COUNCIL ACTION FORM

SUBJECT: ROOSEVELT URBAN REVITALIZATION AREA PLAN AMENDMENT FOR 921 – 9TH STREET (FORMER ROOSEVELT SCHOOL AND NEW CITY PARK)

Attachment A – Request for Amendments – Pg. 1

Attachment B – Approved Building Elevations

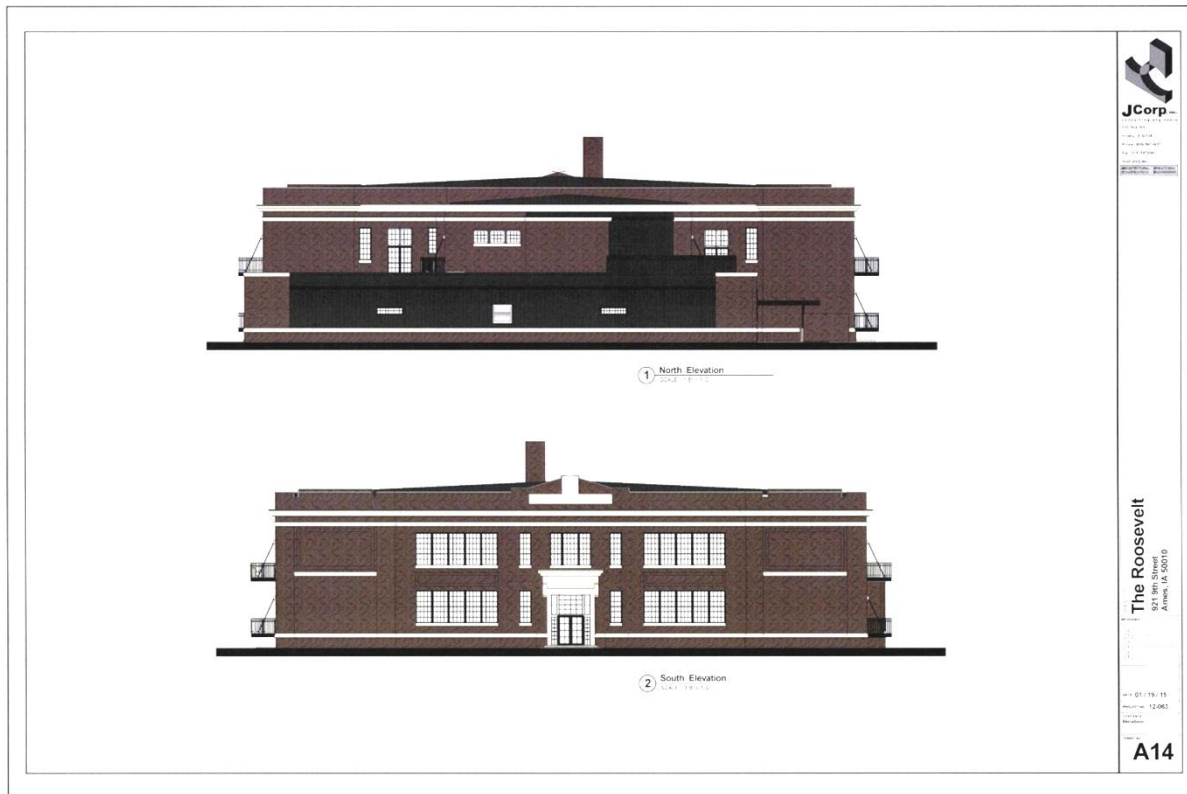
Atrium Materials. The atrium in the approved Plan was shown as glass panels (*Attachment B, Approved Building Elevations*). The atrium as constructed includes glass panels and steel siding materials (*Attachment D, Atrium as Constructed East and West Sides*). The atrium is an important transitional element from the historic school building to the new, attached garage to the rear. In his request for amendments, the developer describes a balance of design considerations with structural engineering requirements for the 2-story stairwell. Such was the case with the reduction of glass surface area in the atrium area as the necessary approach to effectively connecting the new and existing structures together. According to the developer’s explanation, the use of steel siding provided the most viable visual and engineered solution for this area while allowing for soaring glass exposure in the atrium.

Parking structure windows. A parking structure and atrium have been constructed and attached to the north side of the existing building. The adopted URA Plan included windows on the north and east walls of the parking structure to tie the design into the windows of the school building and to increase the aesthetic appeal of the garage facades. As approved in the URA Plan, the north wall is to have three groupings of three windows in each grouping, the east wall is to have two individual windows, and the west wall no windows (*Attachment B, Approved Building Elevations*).

Attachment D – Atrium as Constructed (West and East Sides)

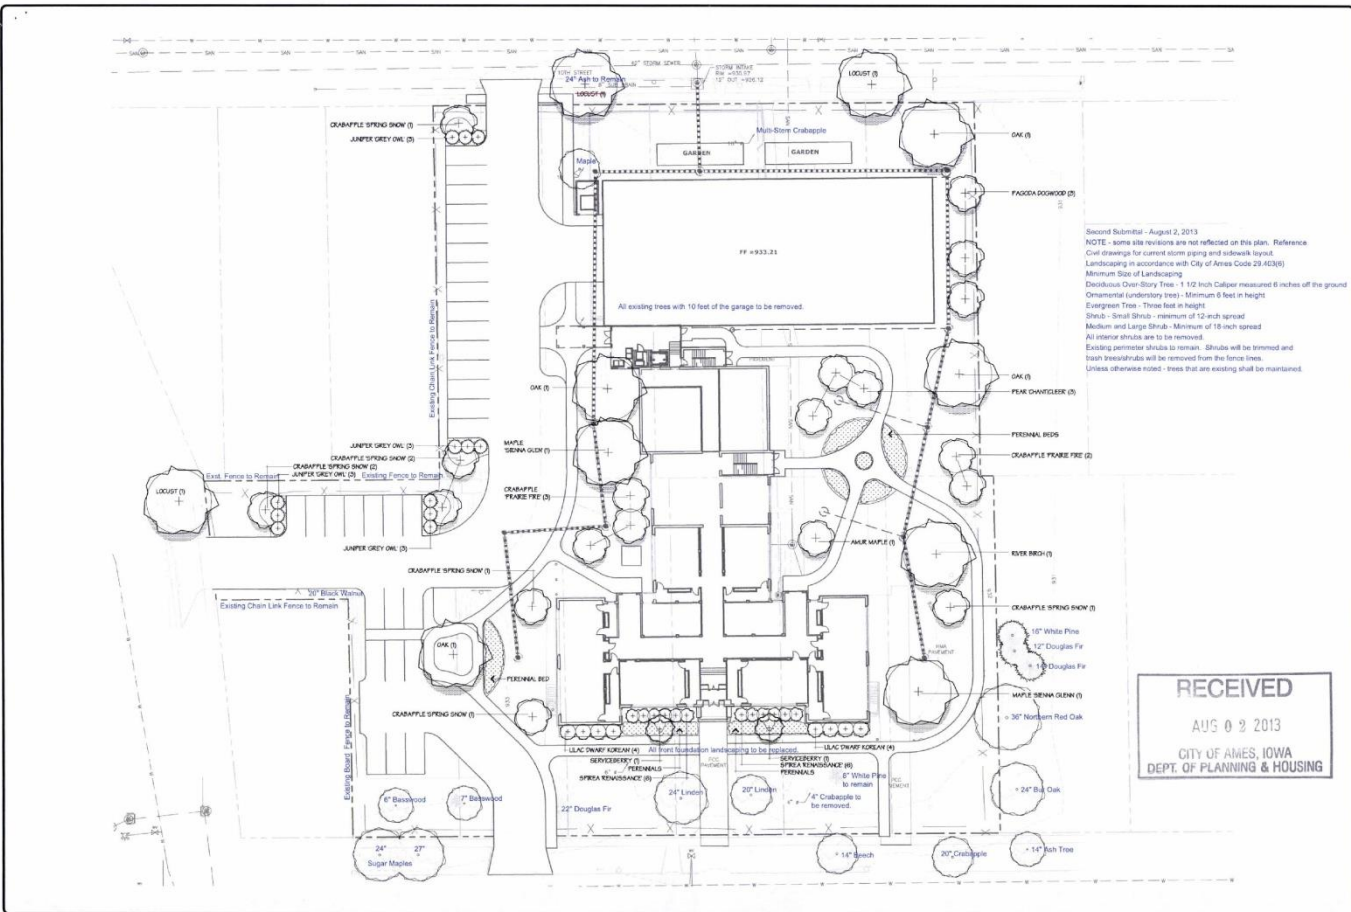
Changes to the Atrium are significantly different than what was proposed with a substantially less amount of glass. Staff believes these changes meet the standards for historic preservation of transitioning from the old to the new in a manner consistent with the Secretary of the Interior's Standards for Rehabilitation. The atrium changes are visible from the neighboring homes to the east and from 10th street, but are set well into the site and appear compatible, even with the modern metal materials.

4. Atrium materials: Balancing design considerations with structural engineering requirements, sometimes not apparent until construction has begun, often requires significant compromise. Such was the case with the reduction of glass surface area in the atrium area as the necessary approach to effectively connecting the new and existing structures together. Use of steel siding, complimentary in color and design to all connected structures, provided the most viable visual and engineered solution for this area while still allowing for soaring glass exposure in the atrium.

Attachment F – Revised Landscape Plan

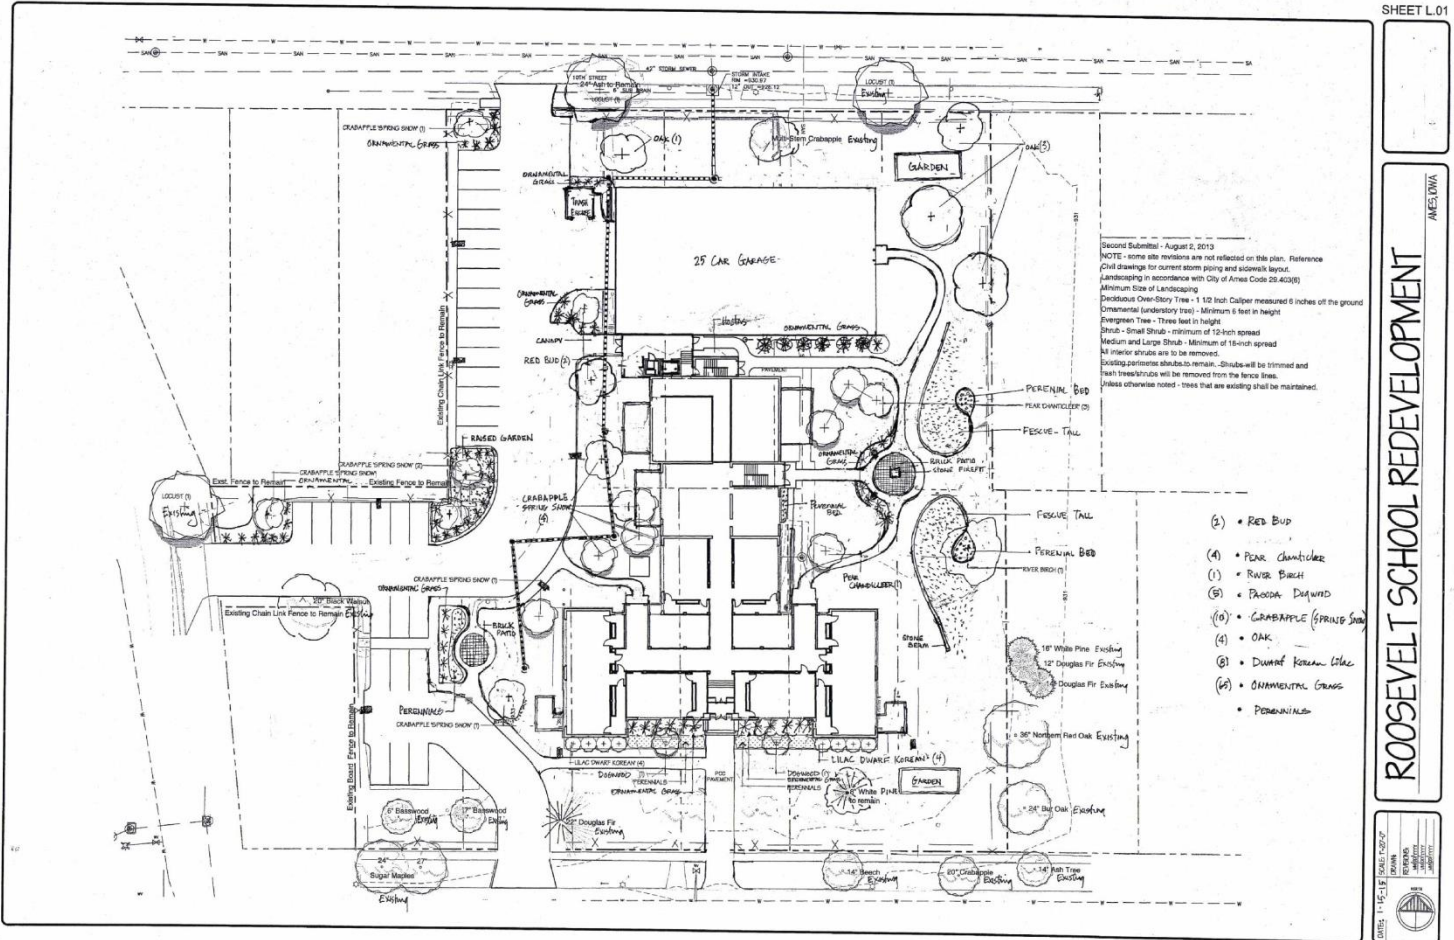
Landscape Plan. The approved Landscape Plan (*Attachment E Approved Landscape Plan*) has been altered by the changing the layout of sidewalks on the site, reducing the number of trees to be planted, eliminating the gardens on the north side of the garage from the Plan, adding planting beds between the building and the City park to the east, and adding a brick patio west of the building (*Attachment F, Revised Landscape Plan*). Additionally, the developer has not completed installation of all landscaping, and requests a provision in the URA Plan to allow to defer planting until Spring. This is allowed under the Zoning Ordinance, and the developer has posted financial security for completion of the revised landscape plan.

5. Landscape plan. Maintaining harmony with the new city park to the east of the Roosevelt while also forming a subtle, tasteful, yet clear boundary between public and private lands was a primary goal in the modified landscape plan. This new plan incorporates these minor modifications without substantially changing the original plan.

- A. A Landscape Plan that includes five trees, either White/Concolor Fir, Blue Spruce, or a combination of both, together with planting beds of perennials and shrubs, distributed throughout the open area between the parking structure and the property line along 10th Street; with the White Fir and/or Blue Spruce trees a minimum of six feet in initial height, at the time of planting, evenly spaced in the open area between the building wall and the property line; with the existing Crabapple tree in this space to remain.
